Randwick Local Planning Panel (Public) Meeting

Development Application Report No. D93/24

Subject: 9-13 Abbotford Street, Kensington (DA/530/2024)

Figure 11: Communal living area calculation plan (left) and Council markup of Level 5 floor plan (Source: PBD Architects and Council Officer markup)

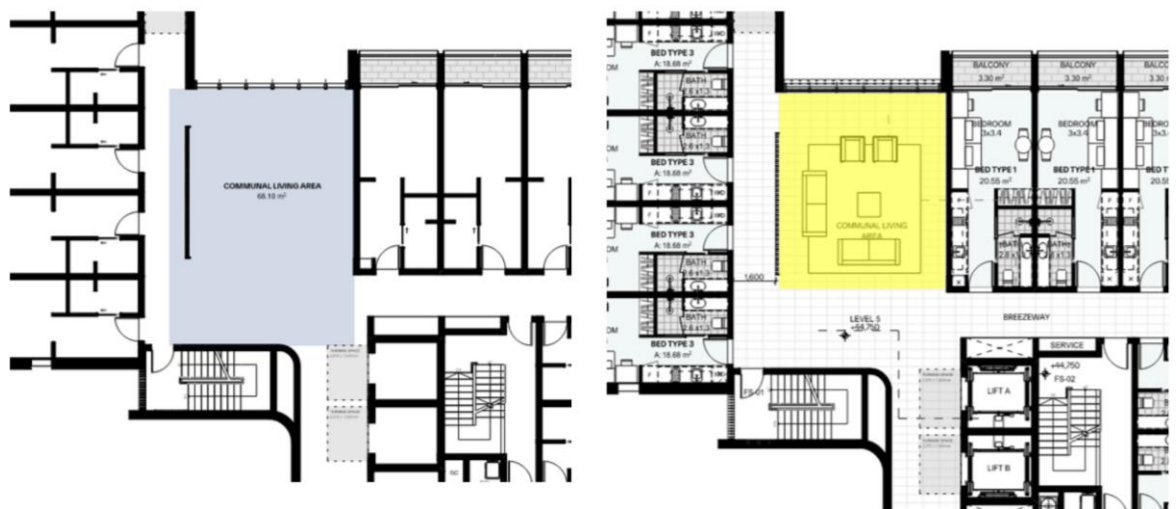
The plans and calculations provided by the Applicant are incorrect. The area of the internal corridors (i.e. horizontal circulation) at ground floor level, Level 3, and Level 5 have been incorrectly included in the calculation of communal living area. Refer Figure 11.

Based on Council's calculations, the proposed development provides 217.58m² of communal living area and so fails to comply with the minimum requirements.

Figure 12: Extract and Council markup of Level 4 floor plan – Room Type 3 (left) and Room Type 4 (right) (Source: PBD Architects and Council Officer markup)

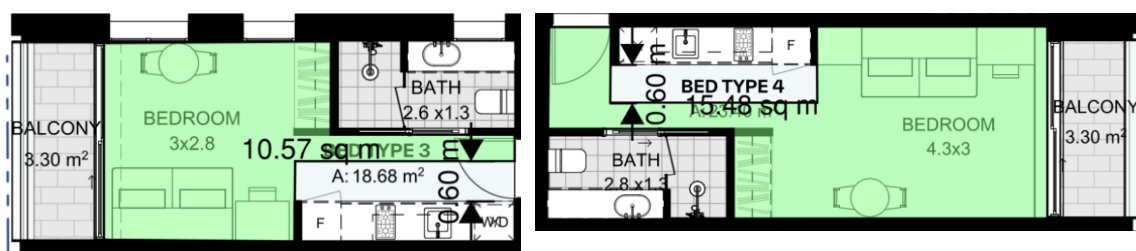
Based on Council's calculations, Room Type 3 (10.57m² for single room) and Room Type 4 (15.48m² for double room) fail to comply with the minimum room size requirements. Refer to Figure 12.

The room layout designs are not suitable as the main entry is through the linear kitchen. No separation is provided between kitchen facilities and circulation, resulting in poor internal amenity for future residents.

Figure 13: Block B Control Plan (Source: Randwick City Council)

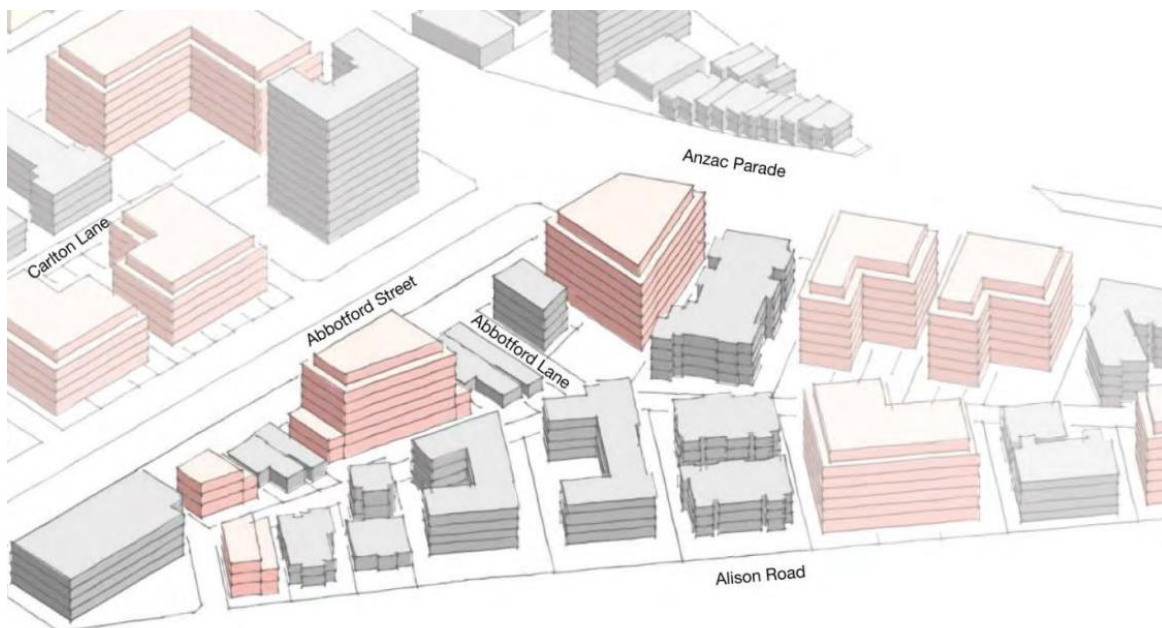
As shown in Figure 13, the Block B Control Plan indicates a maximum seven (7) storey height for 9 Abbotford Street, with a two (2) storey podium to the western side and a 2m upper level setback above the street wall.

The proposed development is eight (8) storeys in height, and as such, is inconsistent with the desired future character of the site and locality.

The Block B Control Plan does not anticipate redevelopment of the heritage item at 11-13 Abbotford Street. However, the proposed development does not retain the heritage item, or provide any transition in scale to the heritage item, which is inconsistent with the desired future character of the site and locality.
